Groundwater Application Review Summary Form

Application # G- 18705

To: Kristopher Byrd, Well Construction and Compliance Section Manager
From: Joel Jeffery, Well Construction Program Coordinator,
Subject: Review of Water Right Application G-18705
Date: May 28, 2019

TO: Water Rights Section Date 5/16/2019
 FROM: Groundwater Section Joe Kemper
 Reviewer's Name
 SUBJECT: Application G- 18705 Supersedes review of NA
 Date of Review(s)

Figure 2. Well Location Map

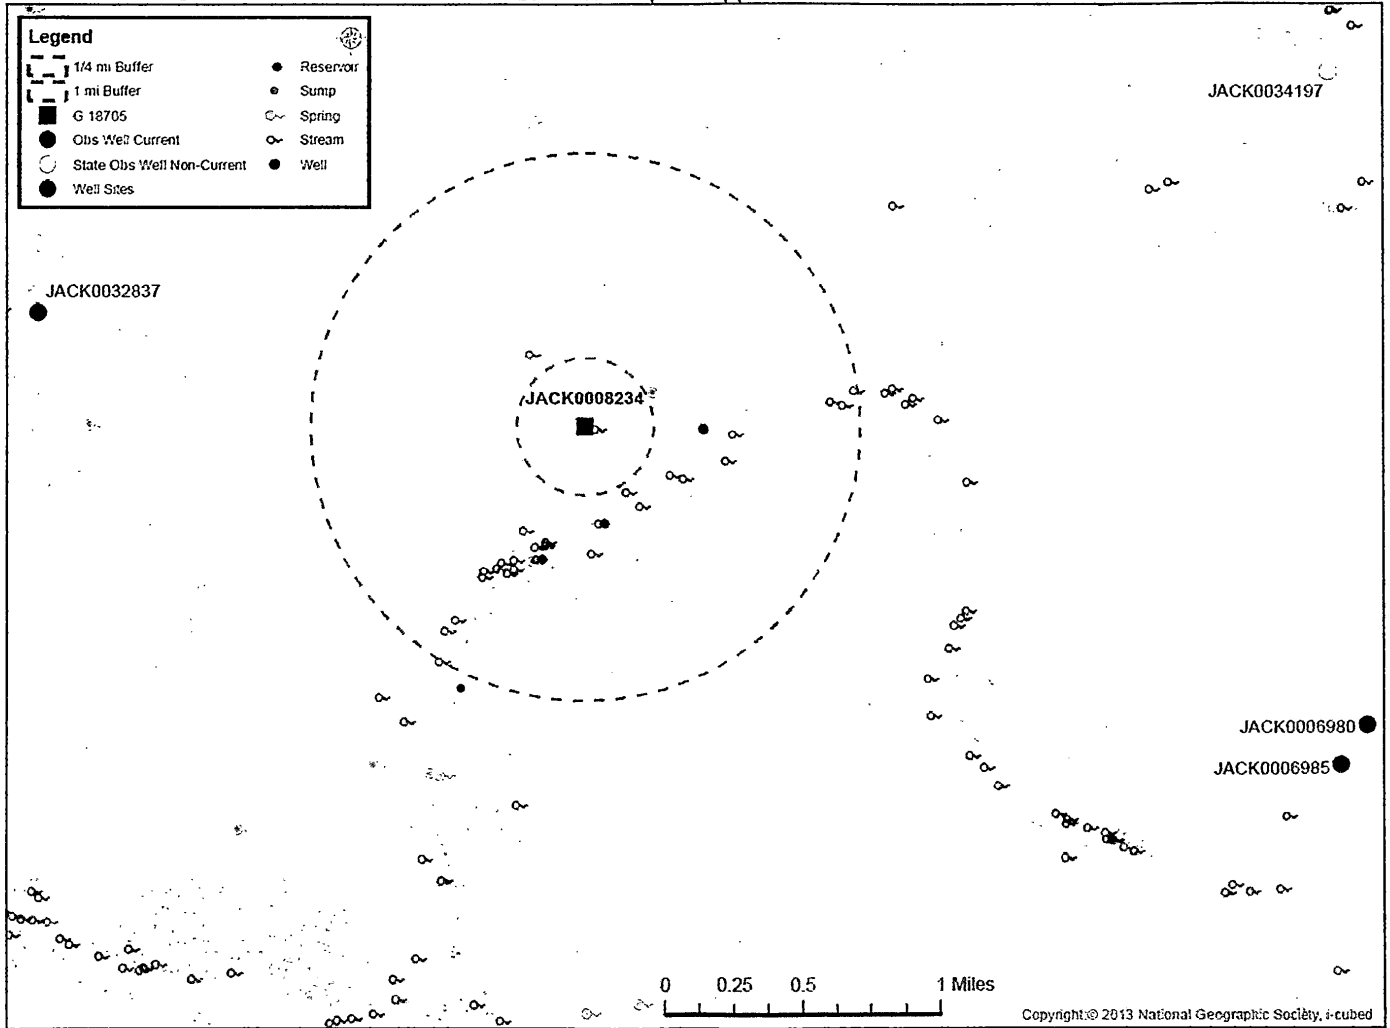
A4. **Comments:** The application map describes the well location as 637.5'S from the NW corner of section 11, but the distance to the physical location indicated on the map is 637.5' S. The applicant will need to submit a corrected application map.
